**REVISION
TO
VOLUME IV OF IV REPLACEMENT
AMENDMENT TO FINAL CLOSURE PLAN
LOPEZ CANYON SANITARY LANDFILL
LAKEVIEW TERRACE, CALIFORNIA**

**BOARD'S COMMENTS ON REPLACEMENT VOLUME IV OF THE FINAL
CLOSURE PLAN FOR LOPEZ CANYON SANITARY LANDFILL**

SUMMARY TABLE OF REVISIONS TO VOLUME IV OF IV REPLACEMENT AMENDMENT TO FINAL CLOSURE PLAN

Subject: Adequacy of the Replacement Volume IV of the Final Closure Plan
for Lopez Canyon Sanitary Landfill, City of Los Angeles, Facility
No. 19-AA-0820

**FIGURE
7-2**

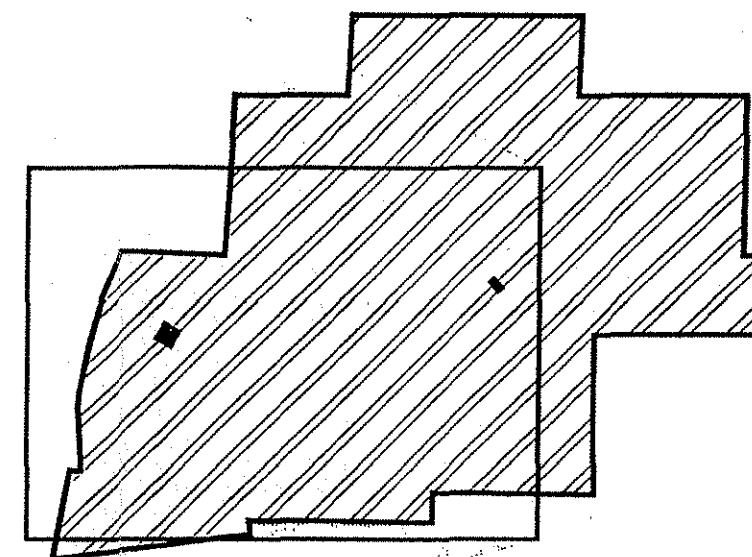
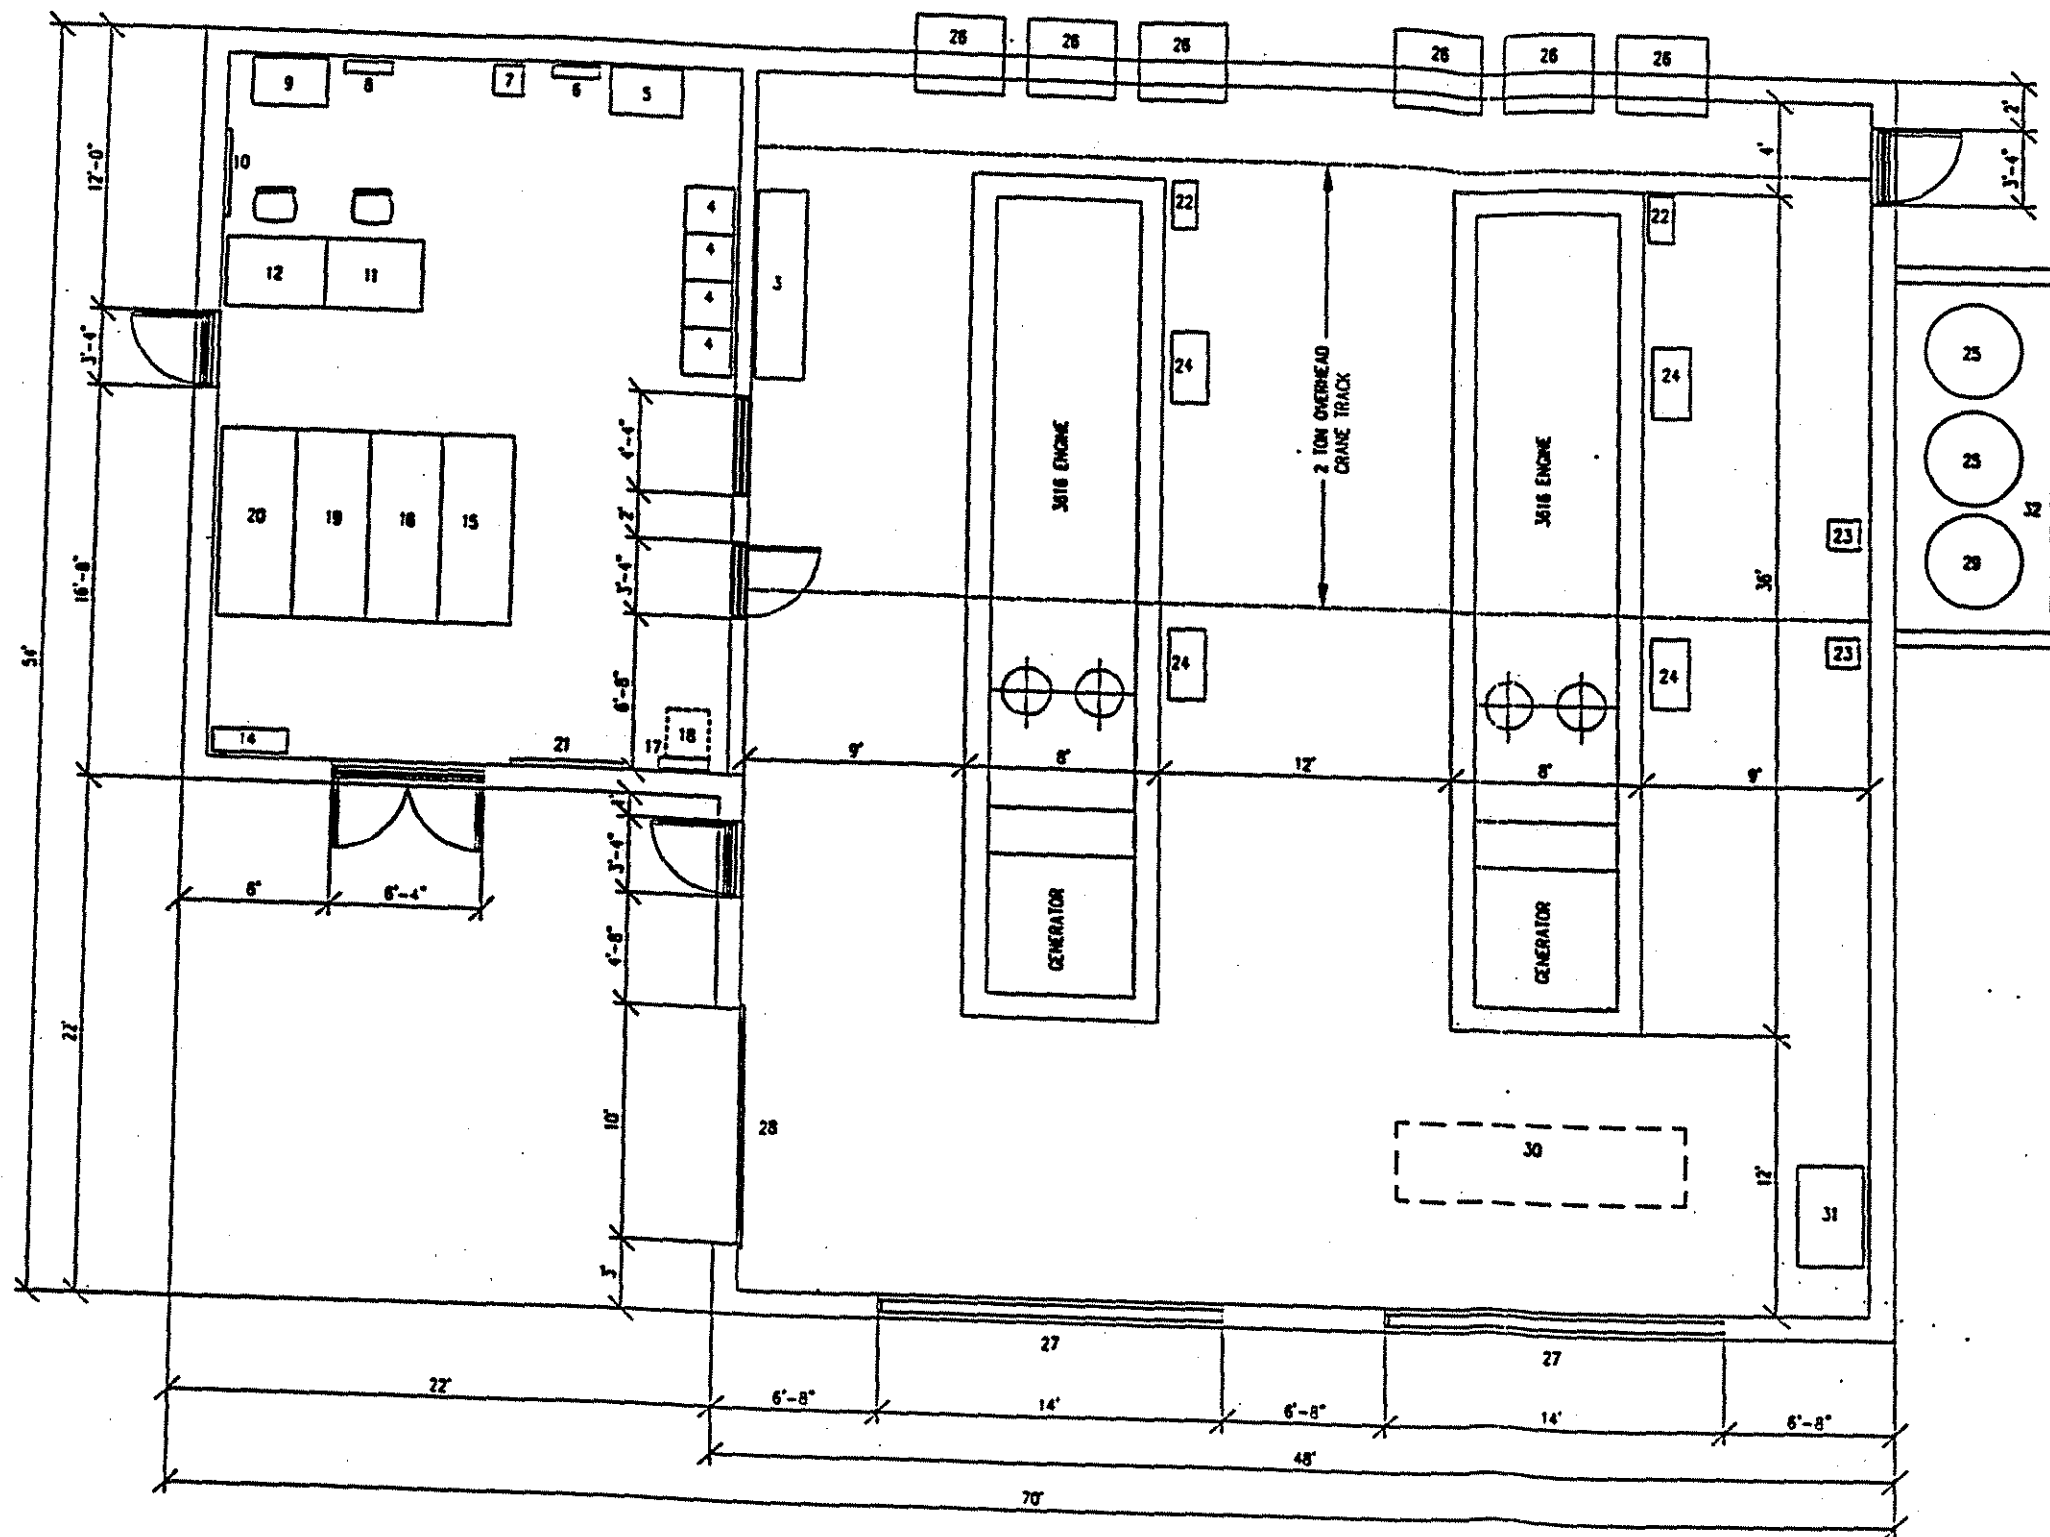
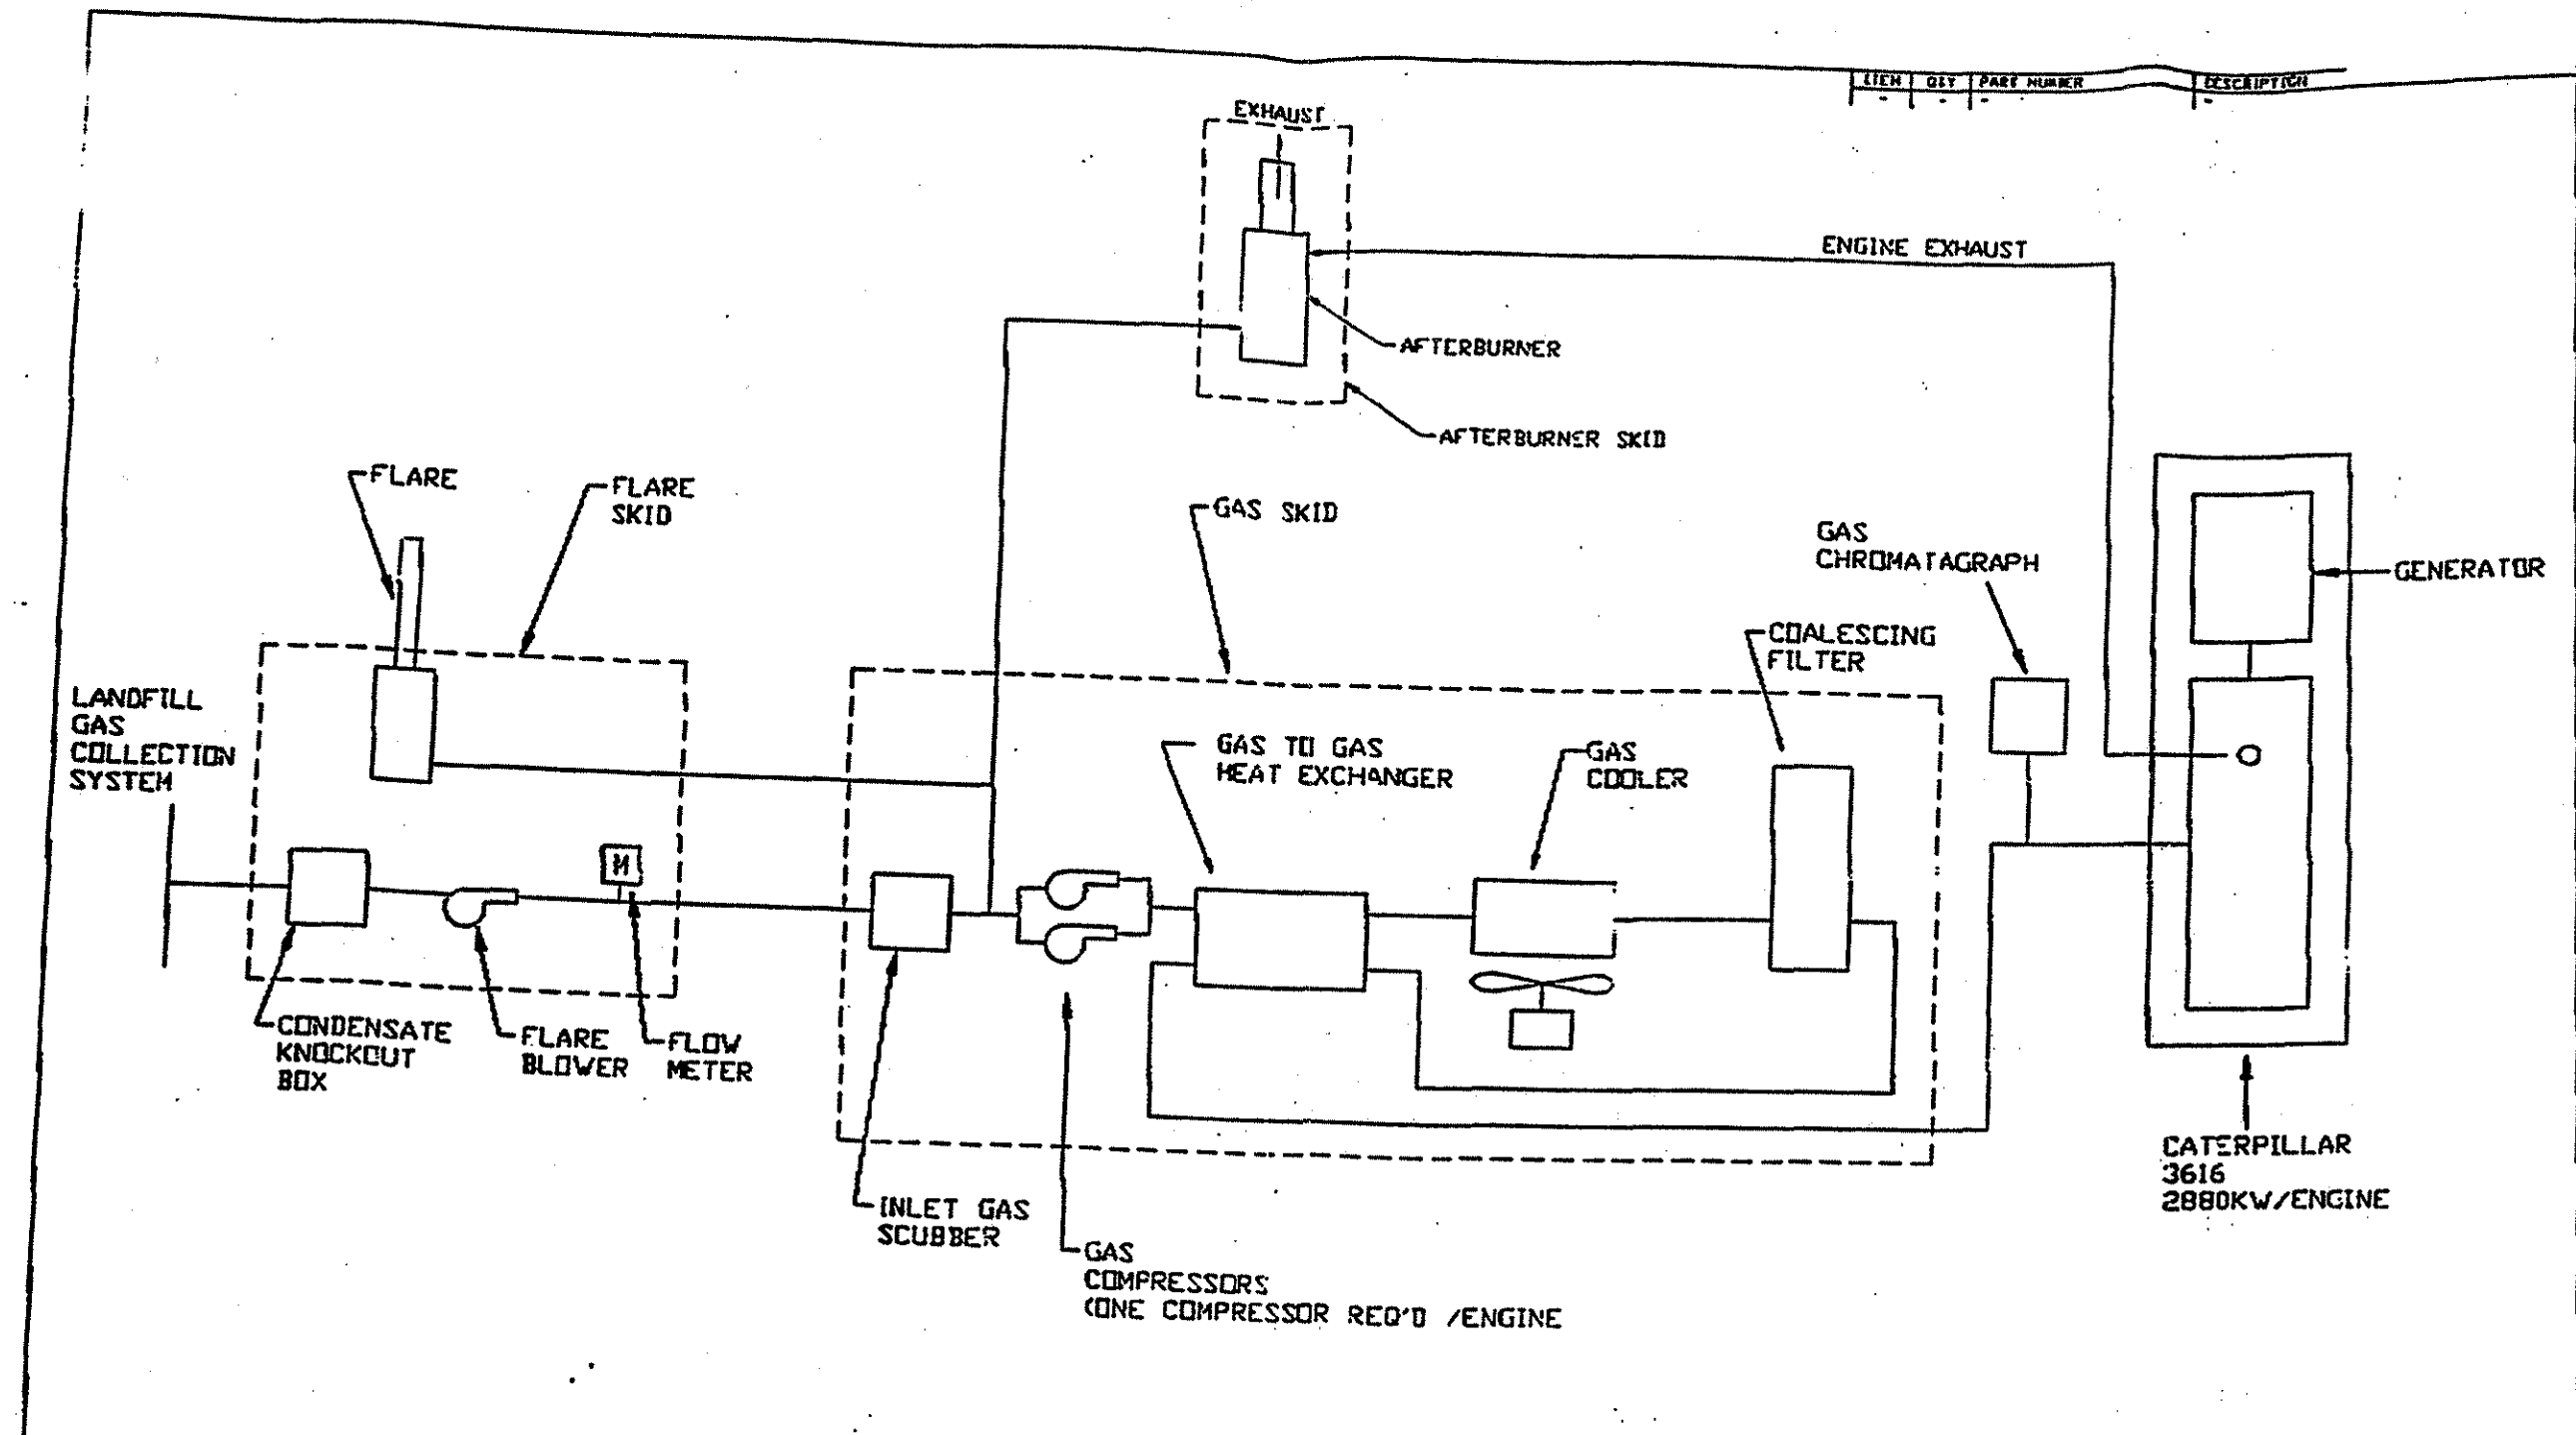
Additionally, the LEA had another comment in a letter to the Bureau dated February 25, 1997, requiring the Lopez Canyon Landfill proposed energy recovery facility (ERF) to be included in the Final Closure Plan.

Section 7, "Revised Landfill Gas Control System," of the Final Closure Plan, has been revised to include Section 7.3 on the proposed ERF. Figure Nos. 7-2 through 7-4 have also been included into the Figures Section of the closure plan. Refer to Attachment J.
